**COMBINED FIELD INSPECTION**

**T.I.P. #:** R-5901

SUBJECT: Project: R-5901 [Intersection Improvements at NC 89 (W. Pine St.) and  
SR 1397 (Round Peak Church Rd./Oak Grove Church Rd.)] Surry County  
WBS: 48416.1.1

**Request for Design Exception**

**R-5901**  
2R02 04

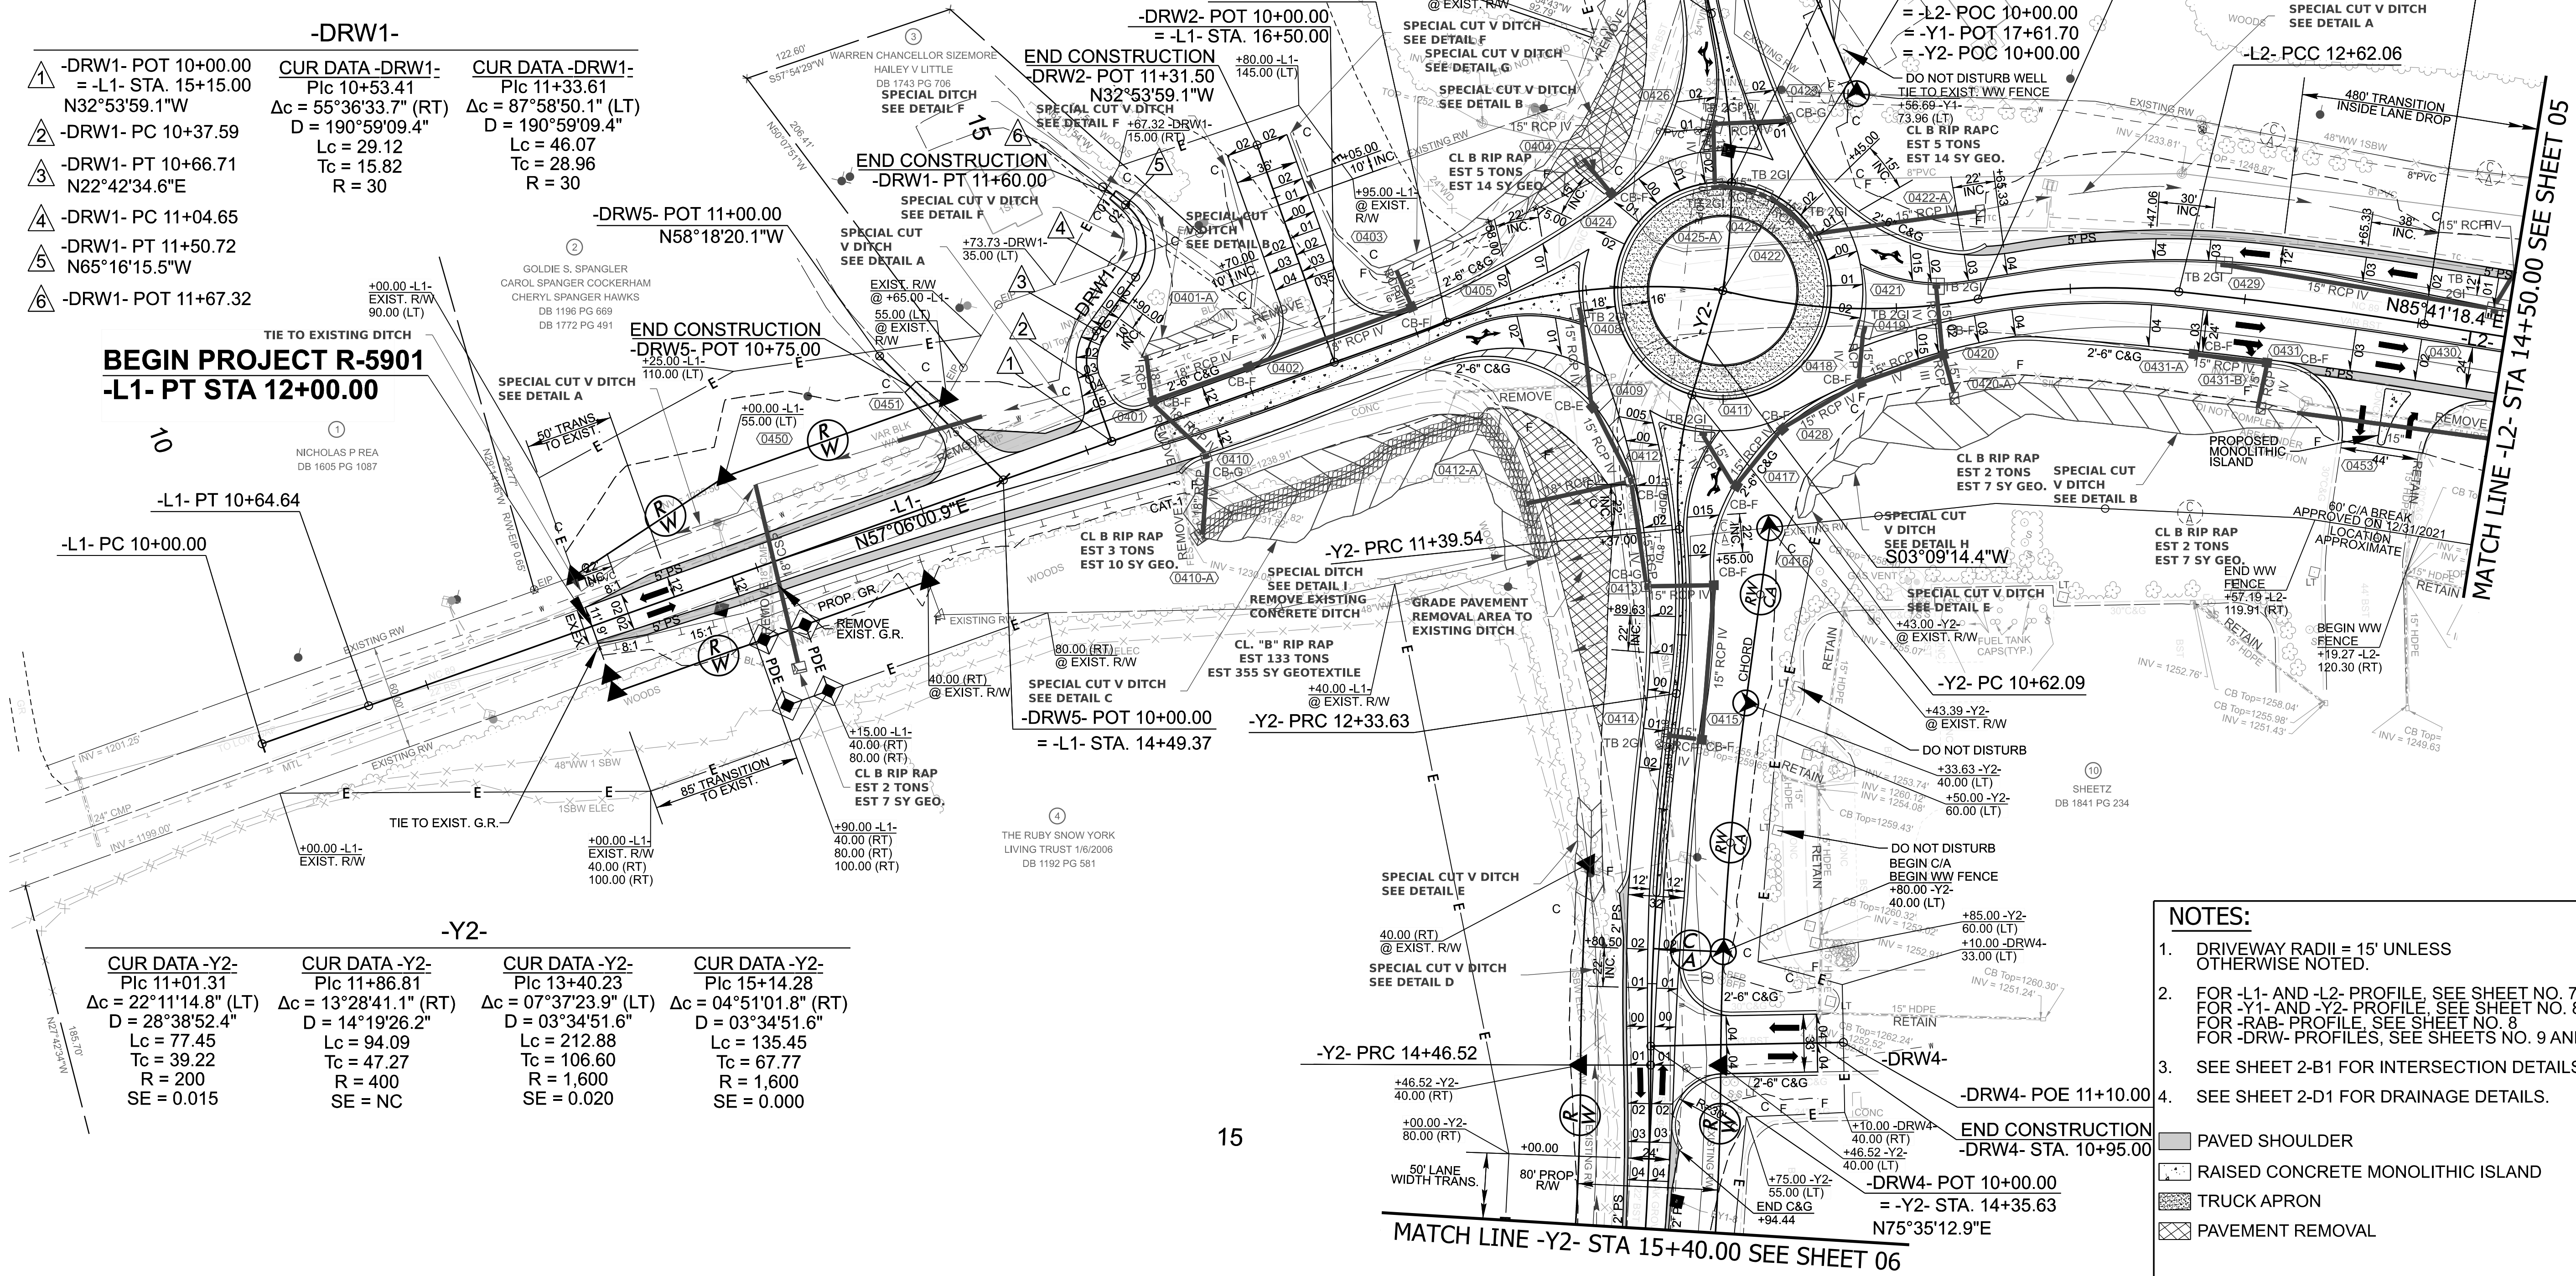
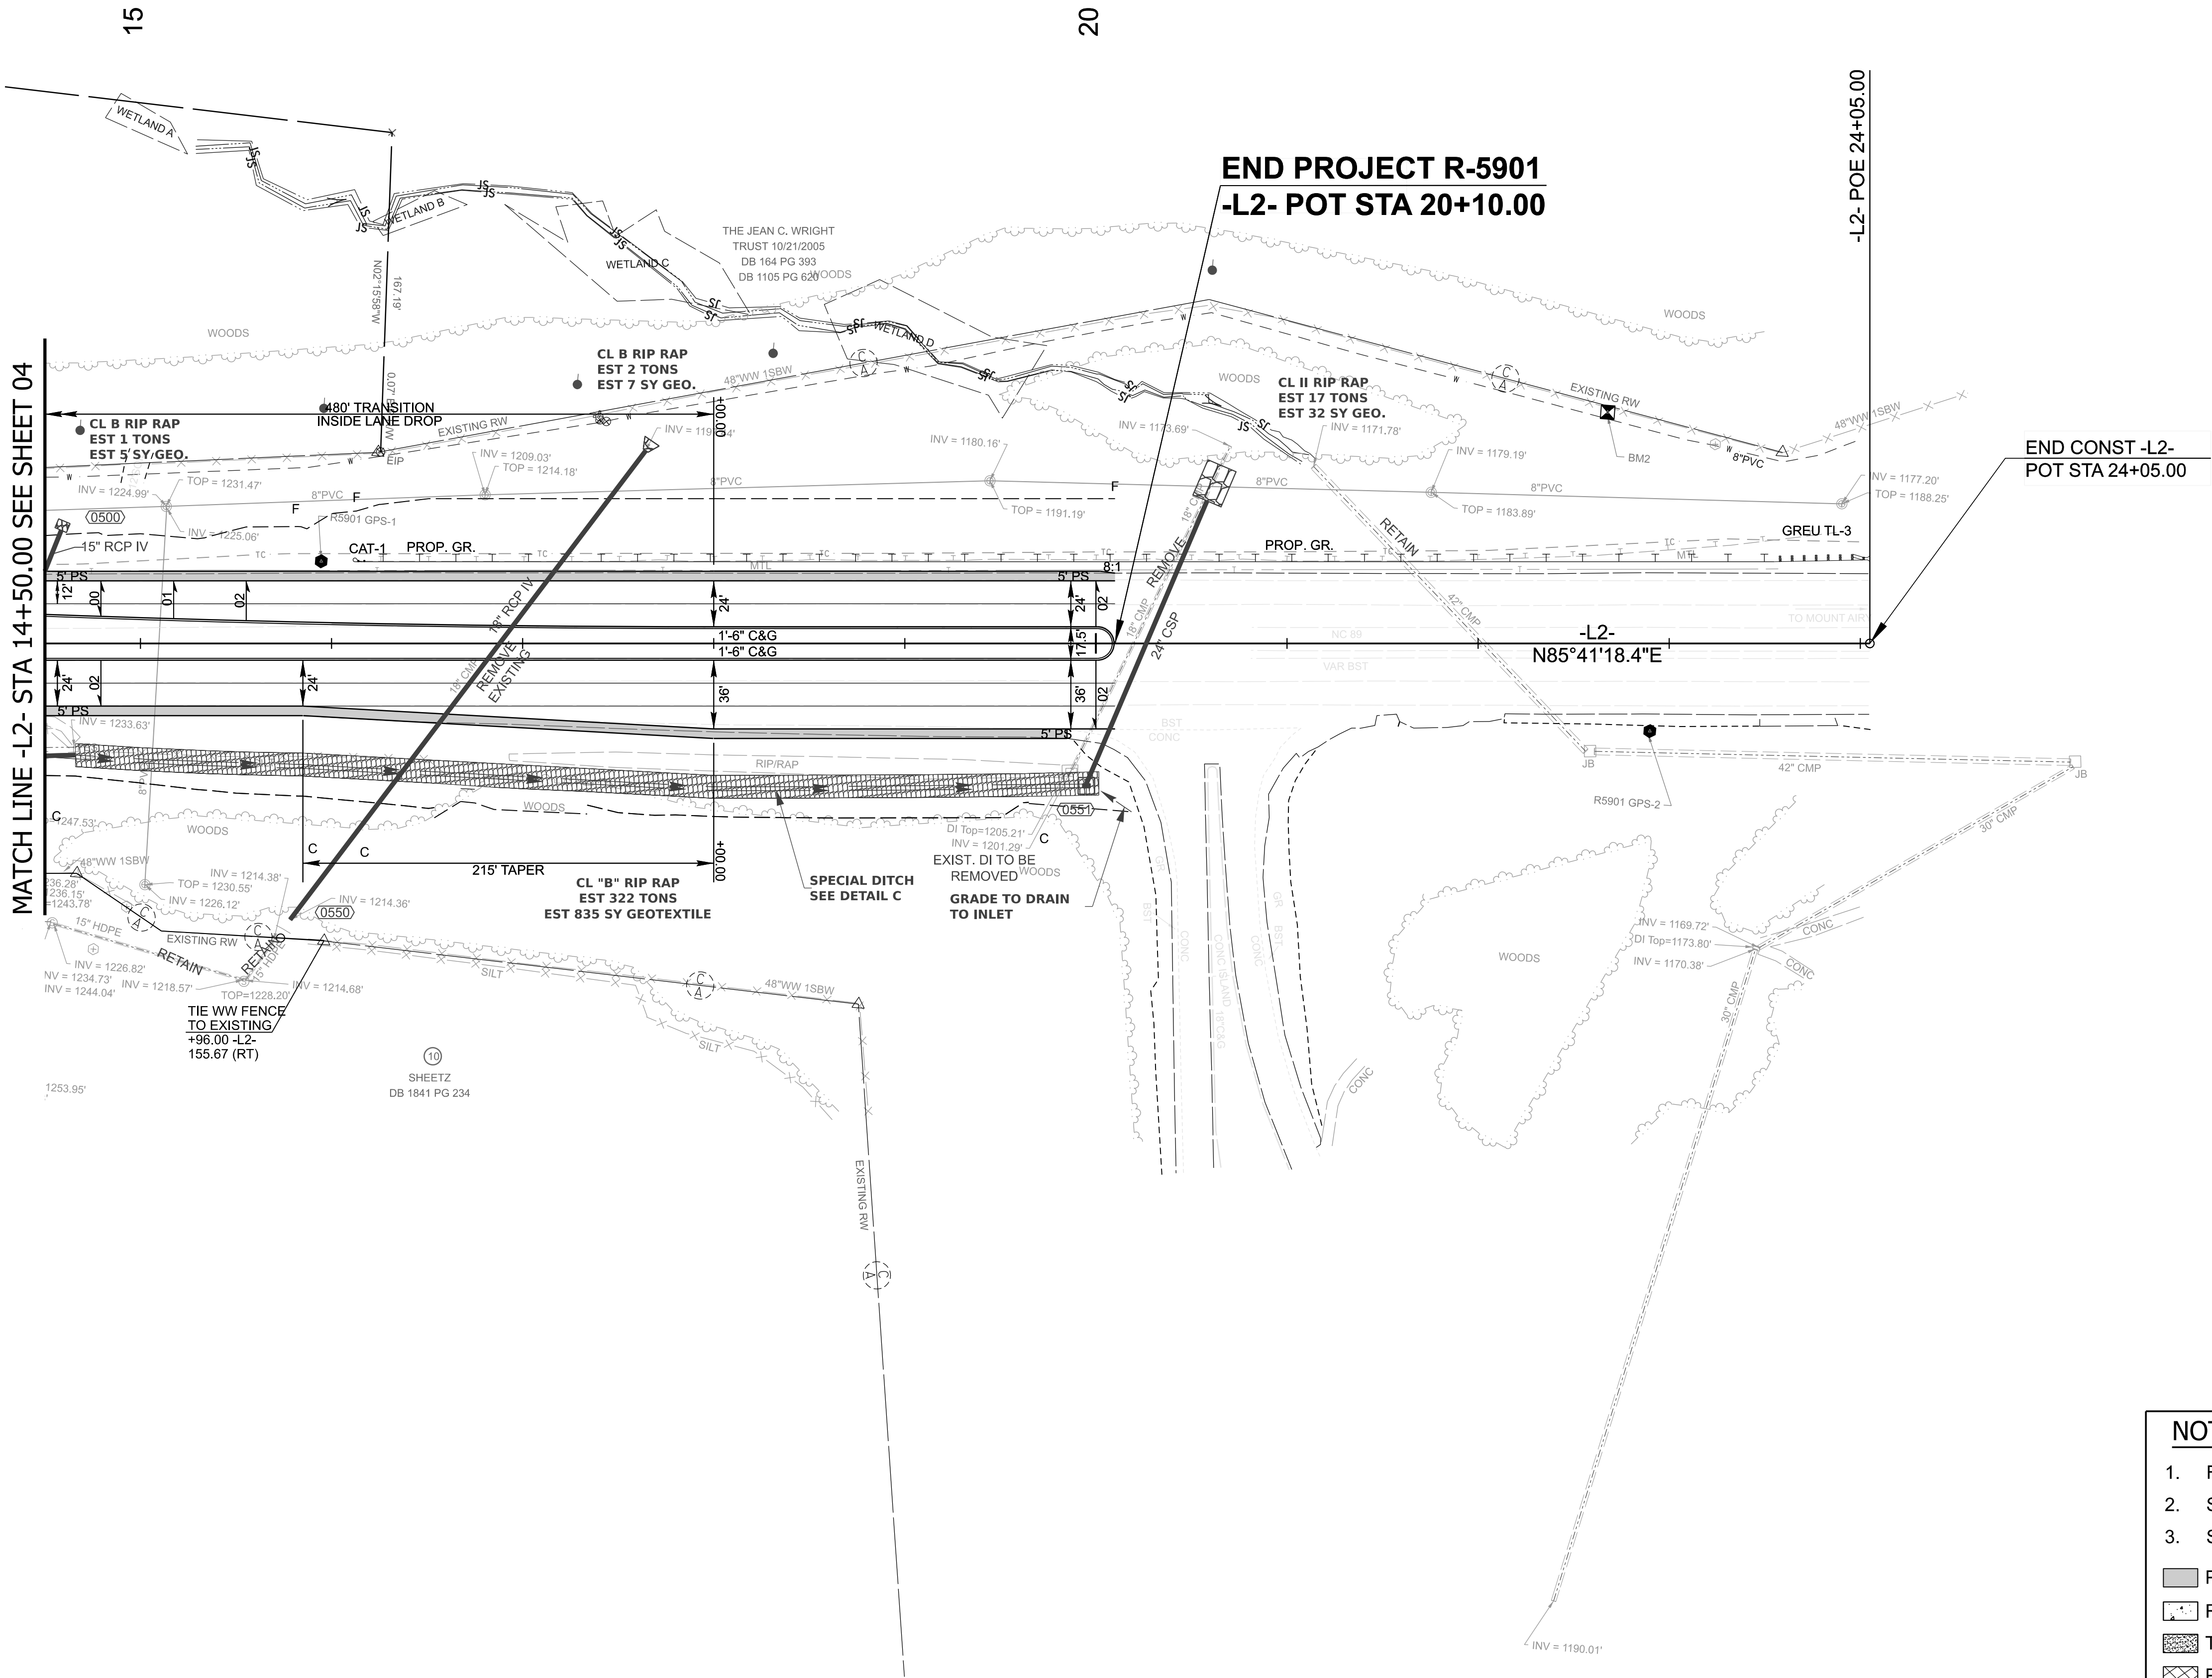
- Location #1:** *(maximum grade)* -L1- (NC 89) Sta. 12+00.00 to 15+30.00,  
varies +6.5443% to +5.0000%

**Location #2:** *(maximum grade)* -L2- (NC 89) Sta. 15+14.53 to 20+10.00,  
varies -5.0000% to -6.0000%

Minimum AASHTO Dimensions:  
**Maximum Grade for -L1- and -L2-**  
AASHTO: 5.0000%  
*The proposed maximum grades on -L1- and -L2- meet 35-45 mph criteria in rolling terrain or 50 mph in mountainous terrain.*

Dimensions Proposed:  
Proposed: (varies) 5.7000% to 6.5443%

**With regards to the maximum grades on NC 89, the steeper (uphill) grades approaching the proposed roundabout on the west and east legs are anticipated to work in tandem with the new roundabout design to encourage vehicles to decelerate as they approach. Although the grades exceed the AASHTO maximum to tie into the existing grades on NC 89, the proposed grades will be lessened within the immediate roundabout approach (2.5% on L1, 1.77% on L2) to provide a flatter slope for vehicles as they come to a yield/stop condition. As part of the proposed improvements, the posted speed limit on NC 89 is also planned to be lowered to 45 mph from west of the proposed roundabout at NC 89 and Beulah Rd to the east side of the NC 89/I-77 interchange.**
